**Date:** August 20, 2010 **PCN No.:** 143

## PRODUCT CHANGE NOTICE

The purpose of this notification is to inform Lantronix' customers of changes to the label of XPort 04 and XPort Pro family of products. Lantronix needed to add higher degree of product traceability, and in addition improve the adhesion of the label to the chassis of the product.

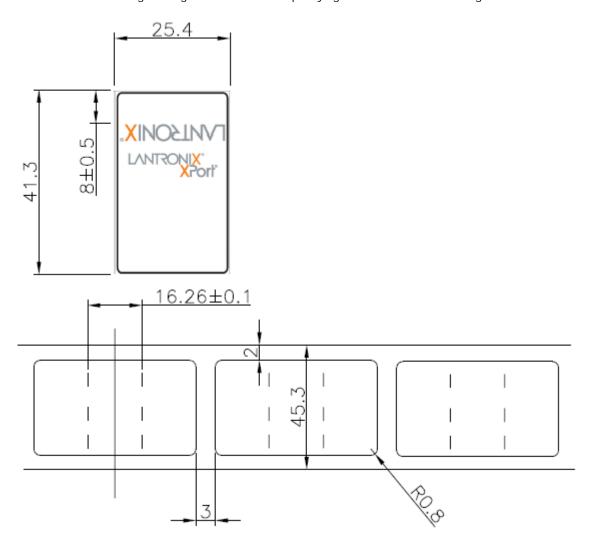
1. The new label will now carry additional information, as detailed below, that will help Lantronix better track products. A sample of the updated labels for XPort and XPort Pro are shown below. The new labels will contain two additional pieces of information, as highlighted in note 9 and note 12.

- 9. Country of Origin & Manufacturing Location ID. Human Readable Text: Font Style = Arial or equivalent. Bold Font. Font Size = 6 pt (approximately 0.06" character height). Content must read literally as "Made in XXX", where XXX is Country & Factory of Manufacturing Origin (i.e. USA, China, China 01, China 02, Malaysia). Place approximately as shown.

- 11. Not Applicable
- 12. Factory Tester Slot ID (Factory use only). Human Readable Text: Font Style & size = Same as Item 9. Content is a value indicating the Factory tester's slot ID. Place 1 space character after Item 9.
